STS-104 FLIGHT READINESS REVIEW

Presenter:
	Organization/Date: Orbiter/06-28-01

AGENDA

Radiator Isolation Valve Circuit

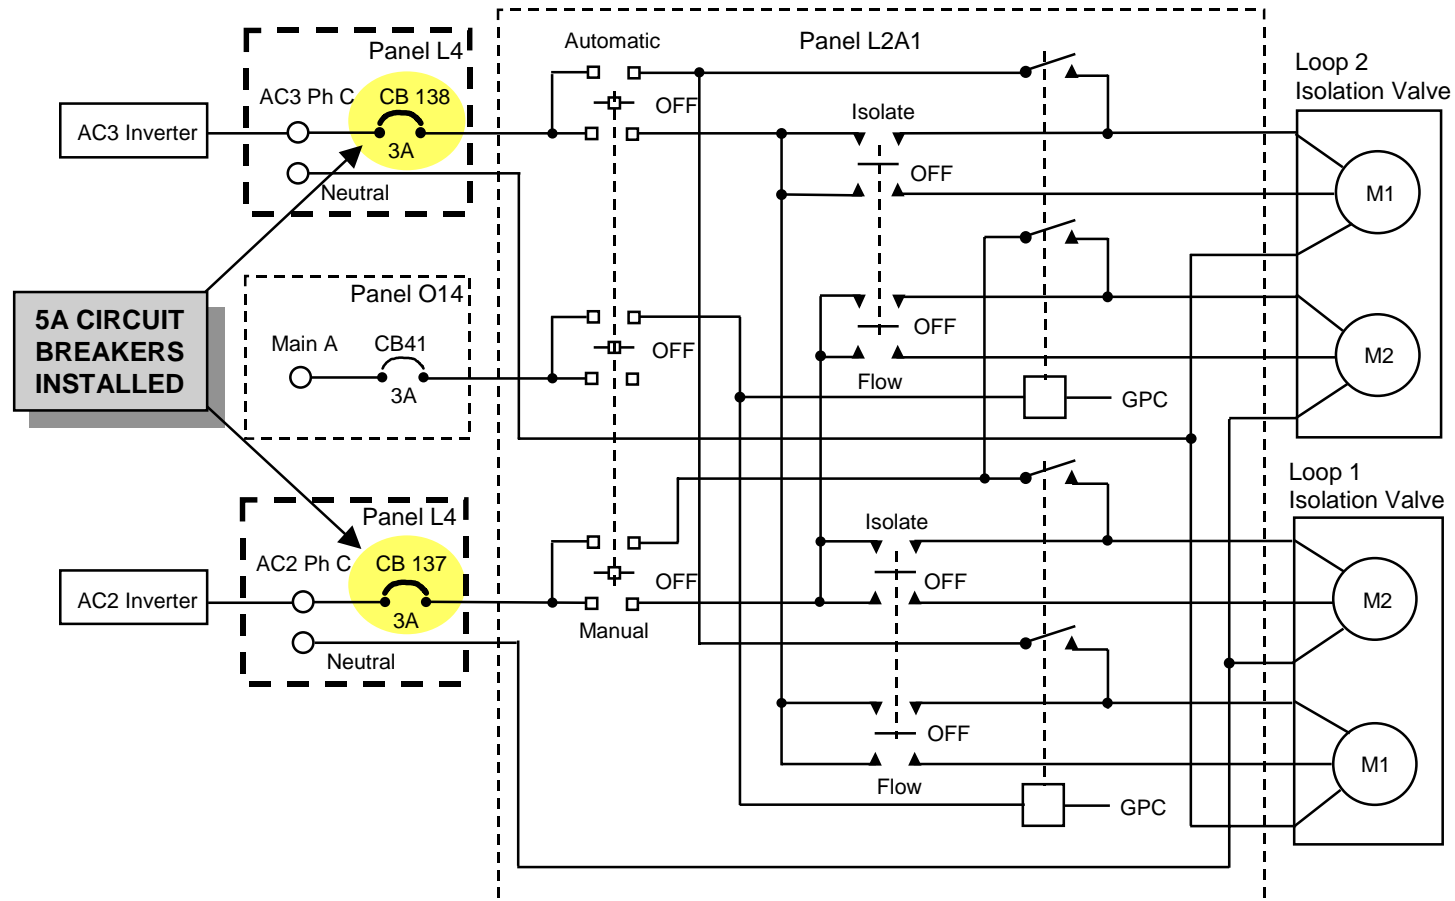
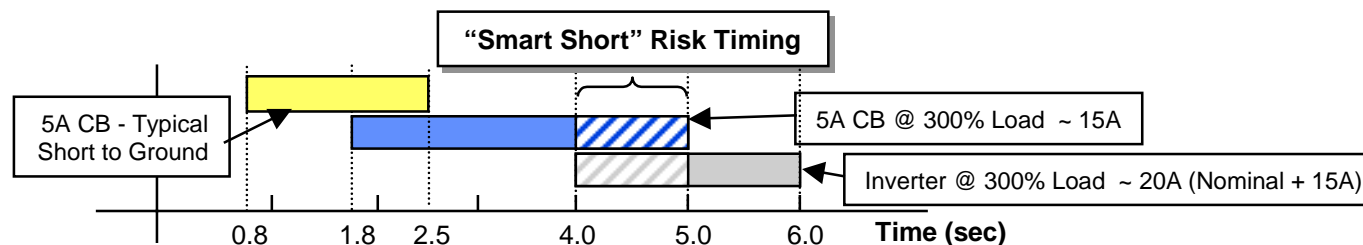
- Radiator isolation valve circuit breakers 137 and 138 on panel L4 are 5 amp, but should be 3 amp

- The maximum current allowed by a 5 amp circuit breaker could cause an over-current shutdown of the associated inverter if a short in the circuit were to occur

- Inverters 2 and 3 provide circuit protection and distribution of AC power through these panel L4 circuit breakers and then through panel L2A1 controls to the radiator isolation valve motors
- The ECN specifies a 3 amp circuit breaker; however, a 5 amp circuit breaker was called out in error on the EO to the assembly drawing

- Circuit stress analysis verified wire is protected under present conditions
- Panel L4 wiring was inspected as part of hinged panel wire inspections - no discrepancies were found
- The OV-104 radiator isolation valves have been cycled to verify circuit integrity
- With a typical short to ground, the 5 amp circuit breaker will protect the circuit
 - A “smart short” (a limited current short that allows the inverter to overload before the circuit breaker trips) could result in an over-current shutdown of the inverter

- Following STS-104, 3 amp circuit breakers will be installed on vehicles equipped with the radiator isolation valve prior to next flight
- Process improvement currently in work at the Boeing H.B. design center to ensure closed loop check of drawings vs. ECN

- The functionality and integrity of the OV-104 radiator isolation valve circuits have been verified
- Exposure to risk is limited to contingency radiator isolation
- Under most short circuit conditions, the 5 amp circuit breaker will protect the circuit
- If the inverter is shutdown as a result of a “smart short”, an IFM procedure is in place to restore PLBD function redundancy

NSLD CRYO SKID TEST STAND

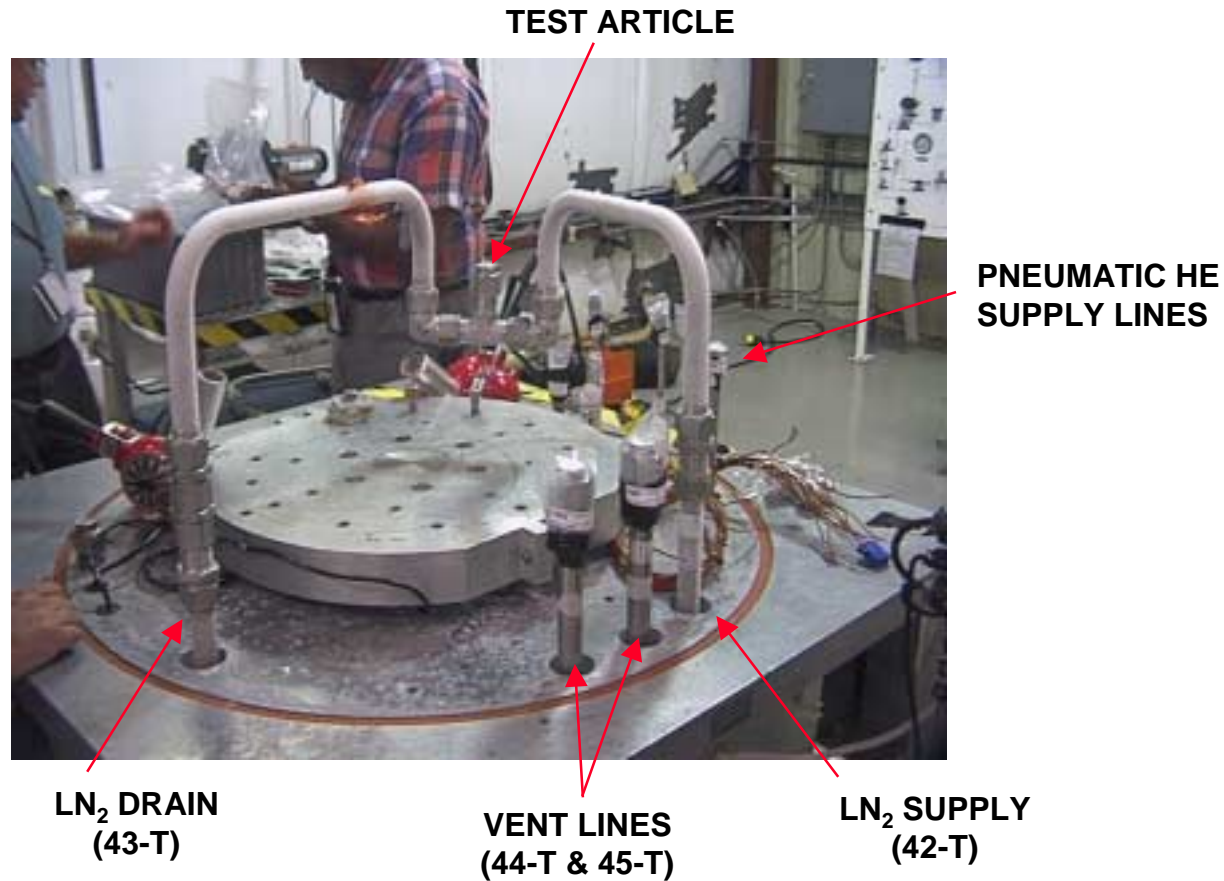
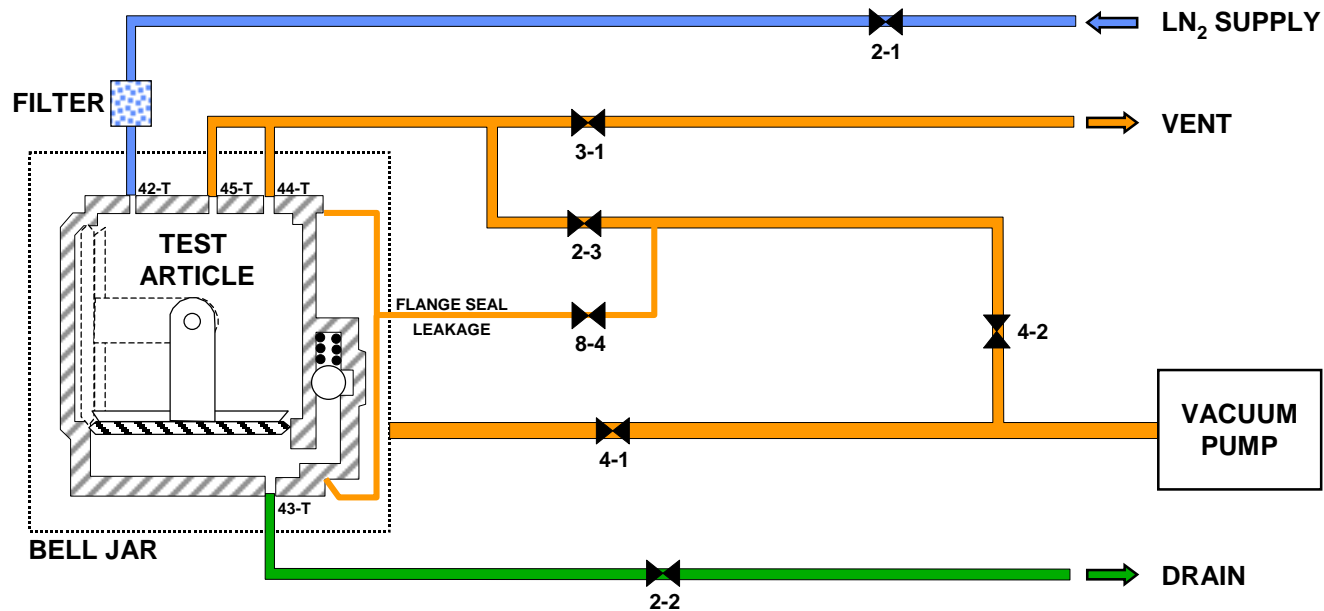
- During disassembly to relocate/upgrade the cryo skid test stand at the NSLD, a hydrocarbon oil contamination was discovered

- Hydrocarbon oil would be incompatible with LOX with potential impact ignition risk to installed LOX hardware processed through the test stand

- Performed analysis of contaminant
 - Determined to be double distilled pure hydrocarbon oil with paraffin from vacuum pump on test skid
- Evaluation of test stand configuration revealed a mechanism for oil migration to test articles
 - Pump seal leakage/back diffusion allows introduction of oil into vacuum lines
 - MPS Prevalve ATP exposes flight valve and LN₂ supply system to vacuum source providing path for oil migration
 - Subsequent testing of PRSD panels and MPS Fill and Drain valves exposes test articles to accumulated oil

ALCA #3 Power Connector Lugs

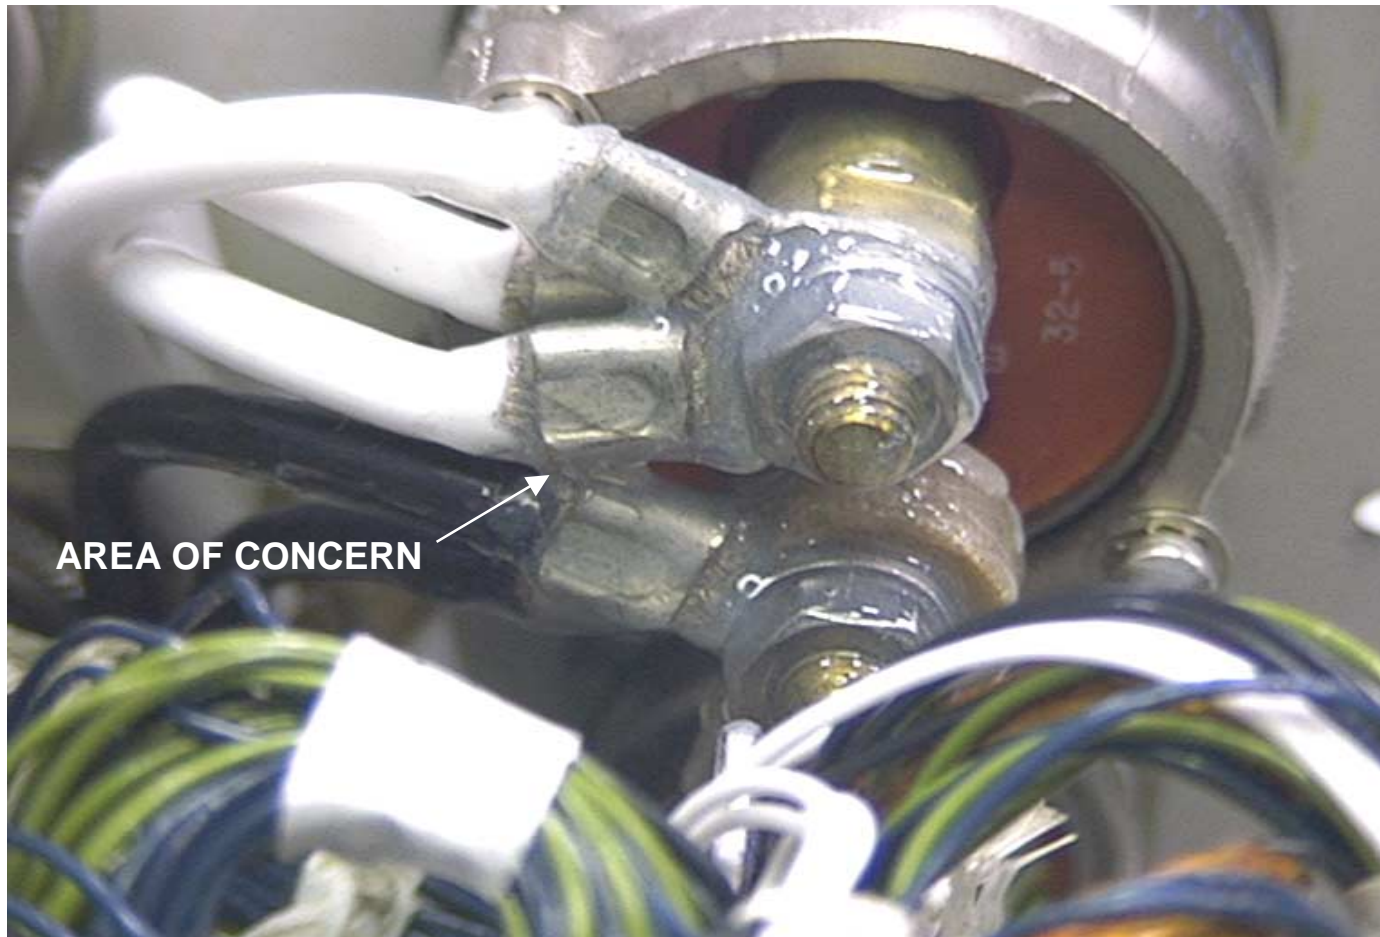
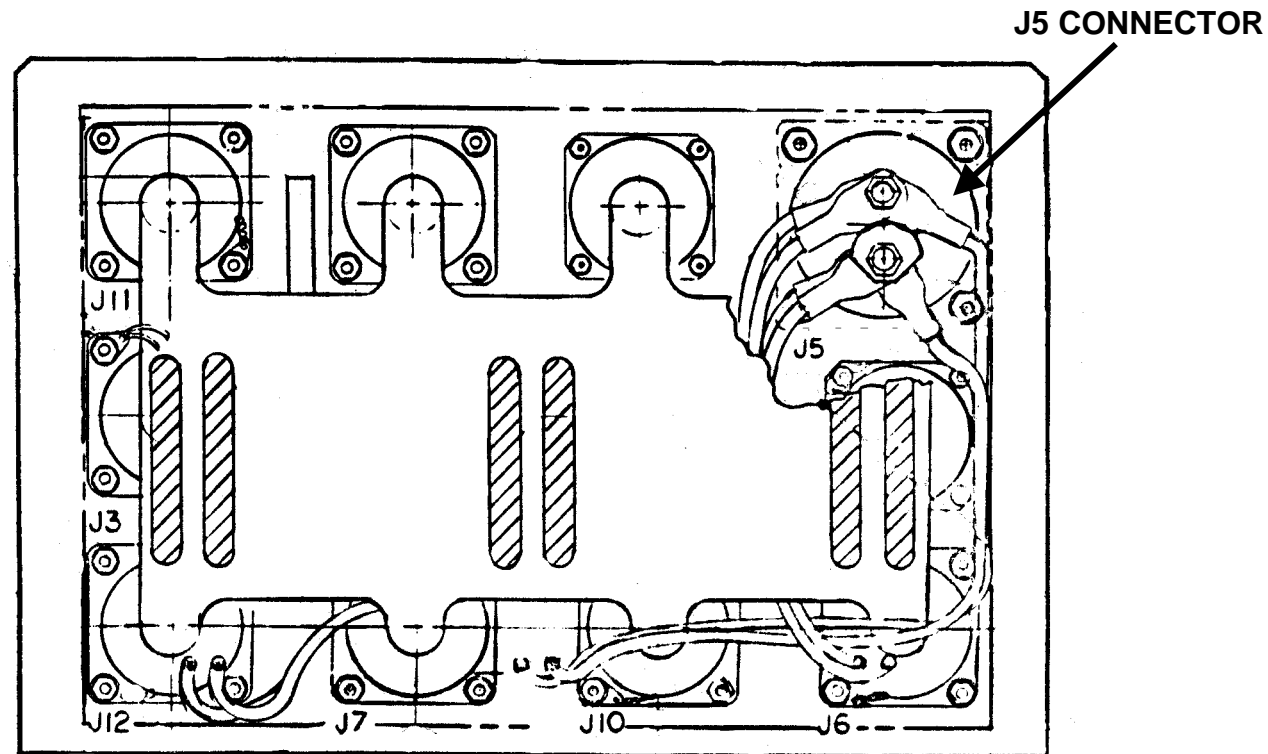
- A potential for a short circuit exists should the two conductors make contact

- Aft Load Control Assembly (ALCA) #3, S/N MYH0001 was undergoing repair for a failed hybrid driver when this issue was identified
 - Visual inspections have determined wire lug separation to be approximately 0.080 inches
- ALCA #3 is the OV-102 original build unit delivered in 1978 and has extensive flight exposure
 - From '81 - '92 it flew 10 flights on OV-102 & OV-103
 - From '94 - '01 it flew 11 flights on OV-104

- Found wire routing was not per assembly drawing
 - Drawing shows one of three wire lugs should be attached from opposite side of J5
 - Although drawing does not specify minimum lug separation, good shop practice is expected
- Reviewed original build data package – no indications of deviations from wire routing requirements per the drawing
- Assessed condition of RTV coating between lugs on S/N MYH0001
 - NSLD reported a solid RTV bridge indicating that there has been no movement or migration of the two lugs in question
- Evaluated other EPDC LRUs to determine if this condition may exist elsewhere – only the ALCAs employ this wire termination design

- While ALCAs are considered acceptable for flight, the inspection data showed that several units were not per print – the PRT concluded that the condition of remaining flight units should be investigated
- The EPD&C PRT is developing a follow-on plan to inspect/rework J5 connectors associated with all ALCAs in the fleet
 - Plan to impose MIL-STD-454K inspection requirement on the NSLD via IDMRD
